BOARD OF APPEALS, CITY & COUNTY OF SAN FRANCISCO

Appeal No. **22-090**

The substance or effect of the decision or order appealed from is the ISSUANCE on December 2, 2022 to Margaret Kishibe, of an Alteration Permit (revision to permit application 2020/0921/4636 of 3rd floor remodel; minor layout change and add shear wall detail and correct existing joist span direction) at 244 Hartford Street.

Application Number: 202211166647
 Form Number: 8
 Address(es): 3602 / 142 / 0 244 HARTFORD ST
 Description: REVISION TO PA 2020-0921-4636 OF 3RD FL REMODEL. MINOR LAYOUT CHANGE AND ADD SHEAR WALL DETAIL AND CORRECT EXTG JOIST SPAN DIRECTION.
 Cost: \$7,522.13
 Occupancy Code: R-3
 Building Use: 28 - 2 FAMILY DWELLING

Elevation of Wall F1 & F2, Existing Condition Elevation of Wall F1 & F2, Proposed Condition

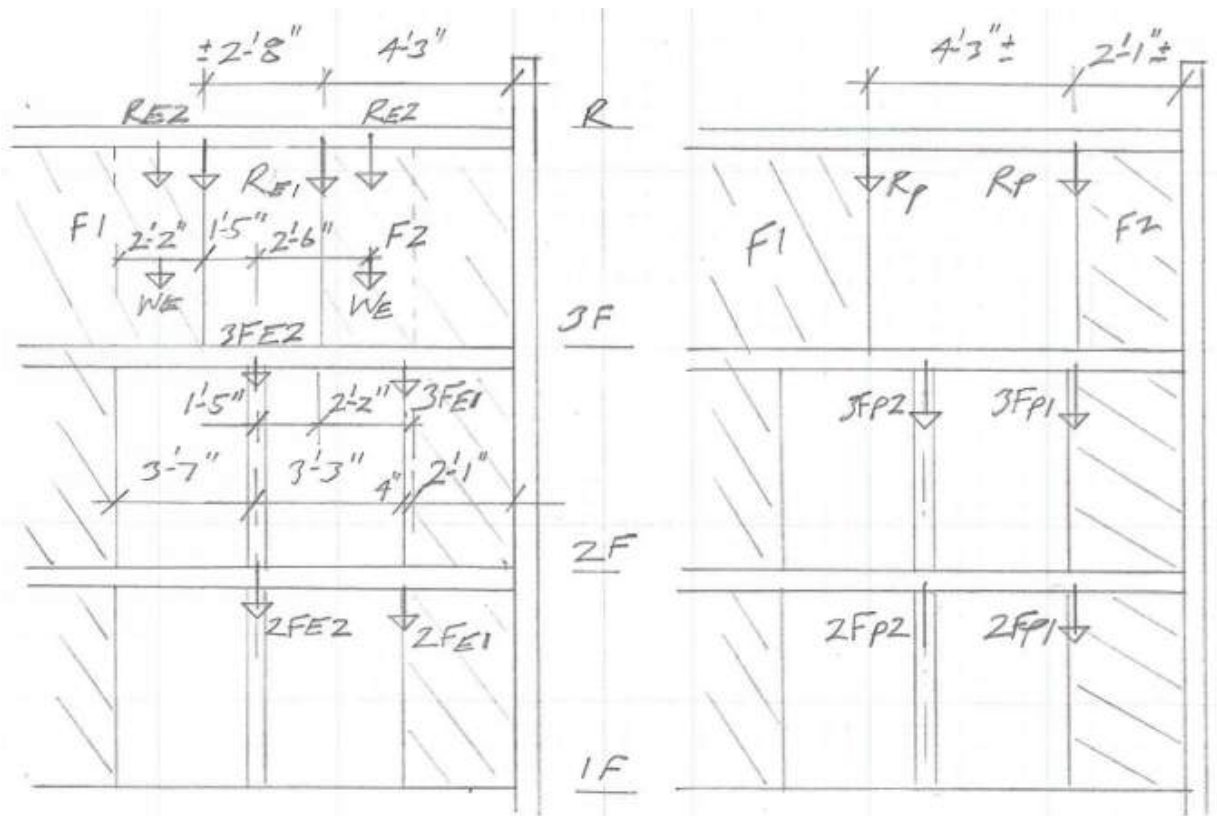
Modifications to walls F1 and F2 will necessitate a new header to support roof framing above the living room which is perpendicular to the wall, per GC field investigation (see proposed floor plan).

A 4x8 header is required between walls F1 and F2 to support the roof framing to the west of walls F, between F and G.

EXHIBIT A: Kitchen ceiling photos showing joists running in north-south direction

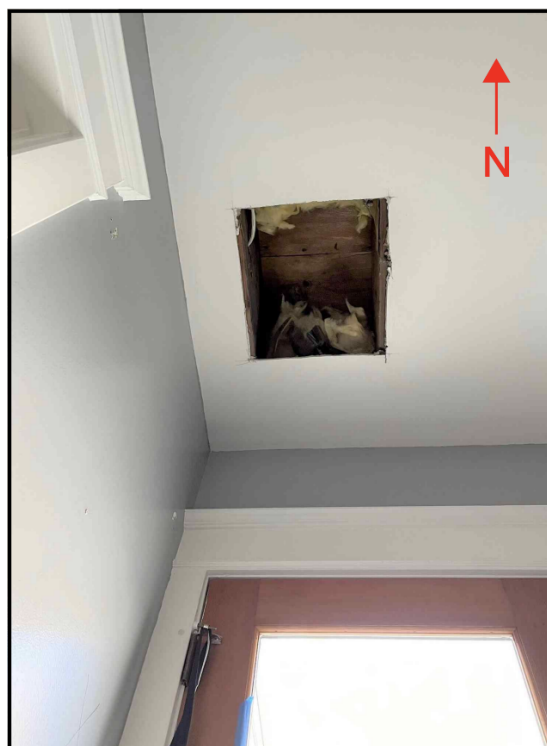
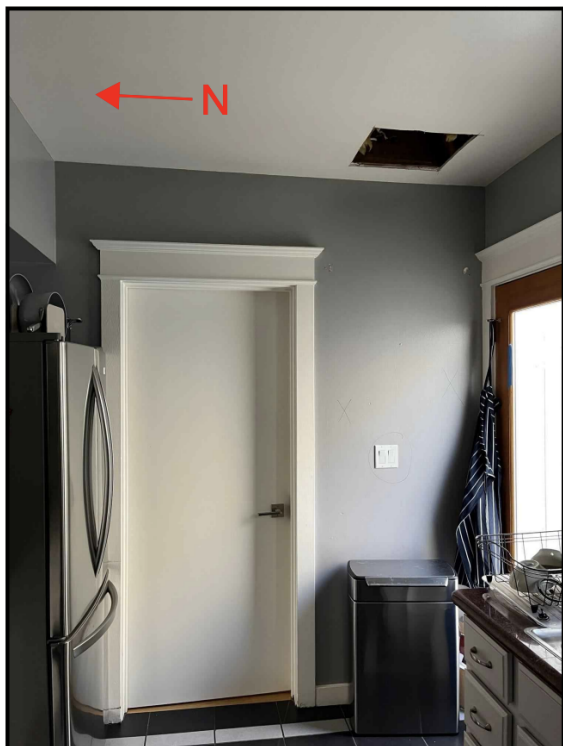
According to my engineer, Alan Burr, *"The 1985 plans show the roof joists in the kitchen area running east to west. Our field investigation shows them running north to south. This is important because the joists above the kitchen are supported on the walls to the north and south of the kitchen, and there is no change to the load path of the kitchen roof as a consequence of the alterations. The roof joists above the living/dining room span east to west as shown in the Revision Permit #202211166647; a new 4'-3" long header will be provided to support the dining room roof joists at the entrance to the kitchen."* (EXHIBIT A, p.7: kitchen ceiling photos)

“The ceiling joist spanning direction of unit 244 Hartford conforms with the revised permit application 202211166647.”.

Hi Maggie,
From the observation during the site visit, the ceiling joist spanning direction of unit 244 Hartford conforms with the revised permit application 202211166647.
Best Regards,

1 (N) 3RD FLOOR PLAN (1,235 SQ FT) SCALE: 1/4" = 1'-0"

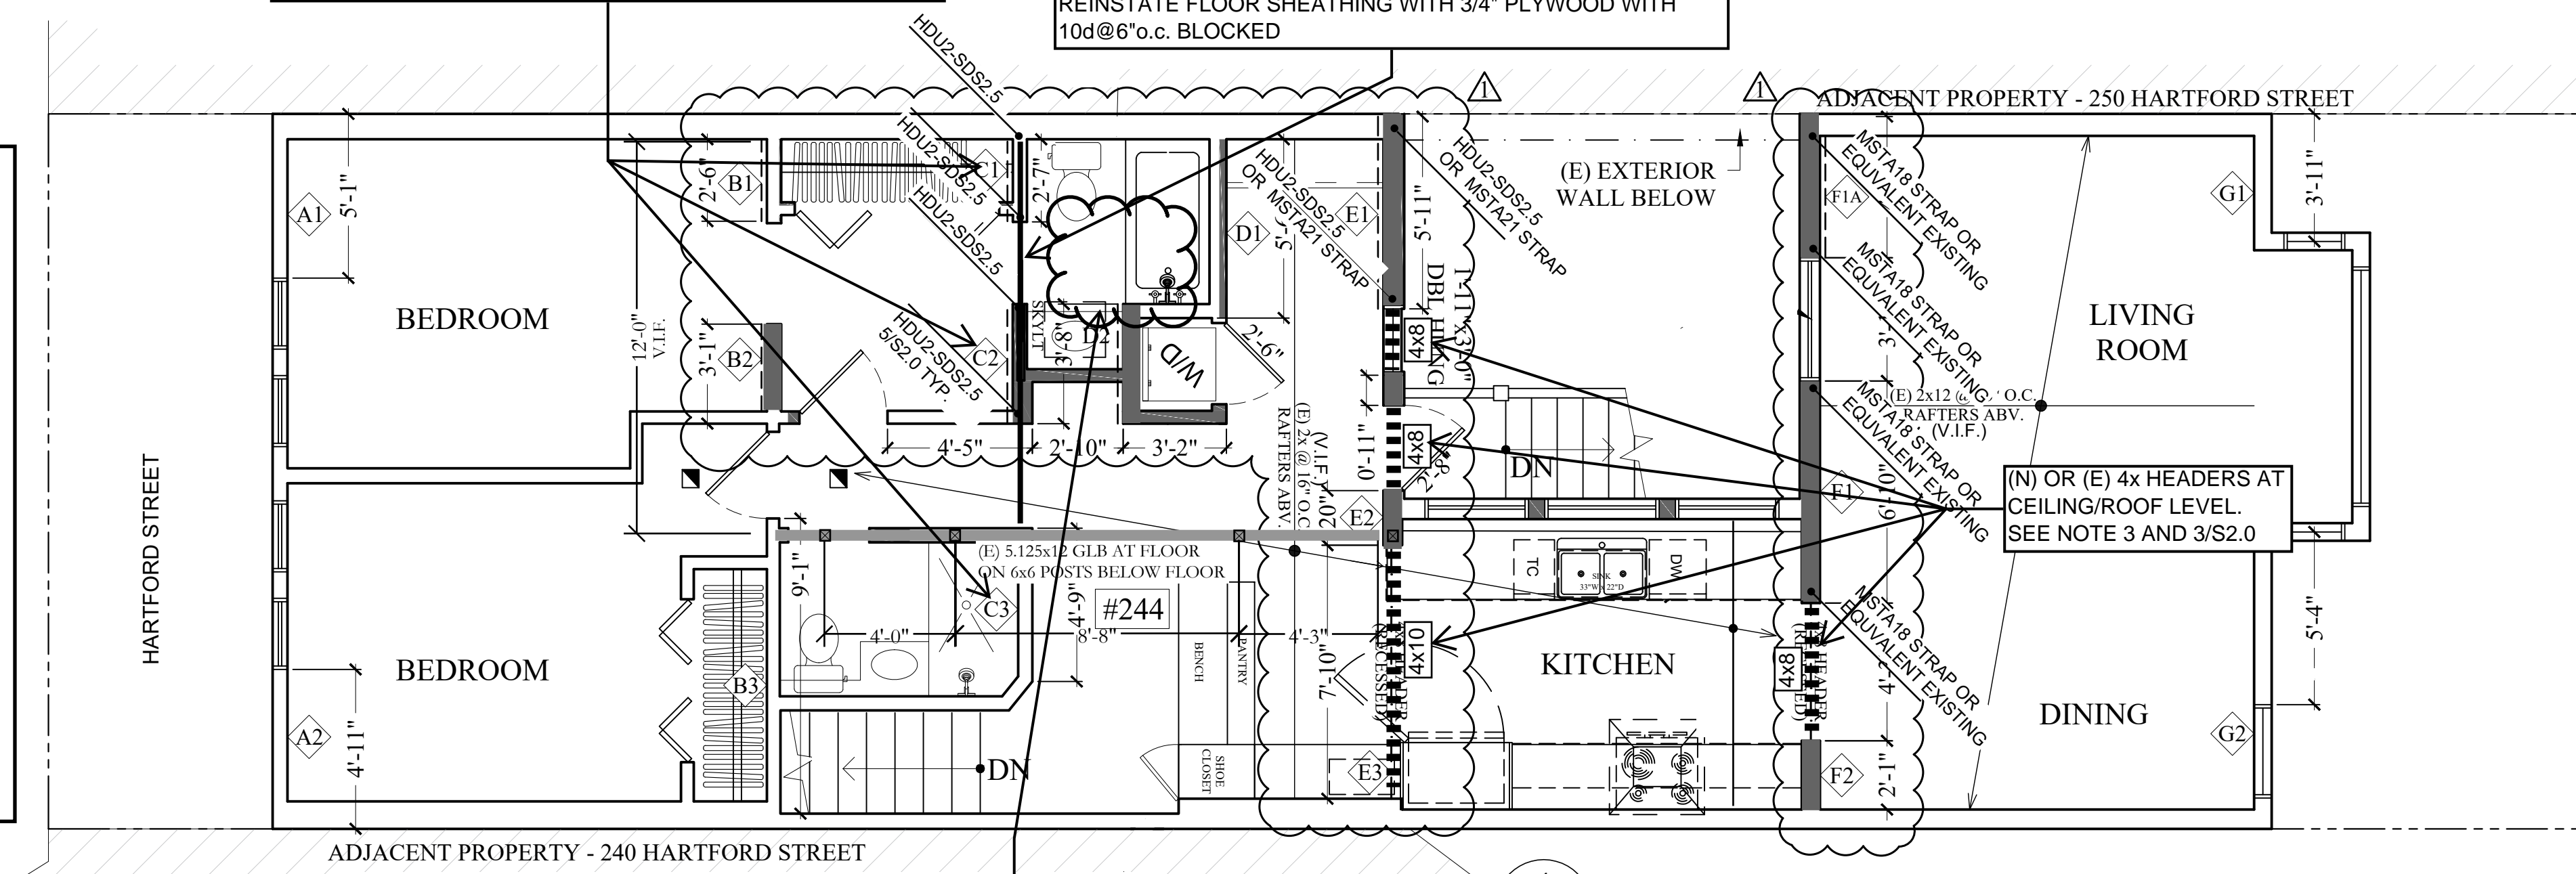
This intent of this letter is to notify SFDBI that permit #2022-11-16-6647 is proposing the removal and modification of existing shear walls along Line E and Line F without proposing adequate seismic strengthening to compensate for the lost shear walls, holdowns, and straps, as required by the 2019 California Existing Building Code (Section 503.4 Alterations). The current permit documents do not call for any new plywood shear walls or other lateral resisting elements to be constructed.

1. All of the walls on Line E and Line F are shown as existing shear walls with holdowns or strap ties to resist the overturning loads
2. The roof joists in the Kitchen are shown as spanning the longitudinal direction (East-West) The approved permit drawings show them spanning in the North South direction.

I hope that information is helpful in assessing the seismic work required if the existing shear walls on Lines E and F are to be removed as set forth in the plans. It is my opinion that new shear walls along these lines need to be brought up to current code, with new holdowns or strapping to address overturning forces, and with adequate fastening of shear panels to roof and floor to address shear forces. The gravity loads also need to be reevaluated given the discovered framing orientation as shown in the 1985 Permit Set.

WALLS C1 AND C2 TO BE SHEATHED WITH 1/2" PLYWOOD, PER NOTE 1. C1, C2 AND C3 TO EXTEND TO ROOF PER NOTE 2 AND DETAIL 4/S2.0.

(N) 6x8 DF#1 BEAM BELOW WALLS C1 AND C2, FROM SOUTH WALL TO (E) GLB. CONNECT AT ENDS TO (E) FRAMING WITH SIMPSON HU610 HANGERS. SEE DETAIL 6/S2.0 FOR CONNECTION AT SOUTH WALL. REINSTATE FLOOR SHEATHING WITH 3/4" PLYWOOD WITH 10d@6" o.c. BLOCKED

- WALLS AT LINES C, D, E AND F TO HAVE EITHER EXISTING 3/8" PLYWOOD, OR NEW 1/2" PLYWOOD ON ONE SIDE, WITH WITH 8d @ 6" o.c. NAILS AT PANEL EDGES AND BOUNDARIES AND 8" o.c. FIELD NAILING. SEE DETAILS 2/S2.0 AND 4/S2.0
- WALLS AT C LINE TO BE EXTENDED TO THE ROOF DIAPHRAGM ABOVE THE CEILING PER DETAIL 4/S2.0
- NEW 4x HEADERS (SIZE AS SHOWN IN PLAN) TO BE SUPPORTED ON 2x4 STUDS AT EACH END WITH 2x4 KING STUDS. SEE DETAIL 3/S2.0
- HOLD-DOWNS FOR WALLS C1 AND C2 PER DETAIL 5/S2.0
- PROVIDE TEMPORARY SHORING AS REQUIRED FOR INSTALLATION OF HEADERS
- WALLS AT A-LINE AND G-LINE ARE UNCHANGED
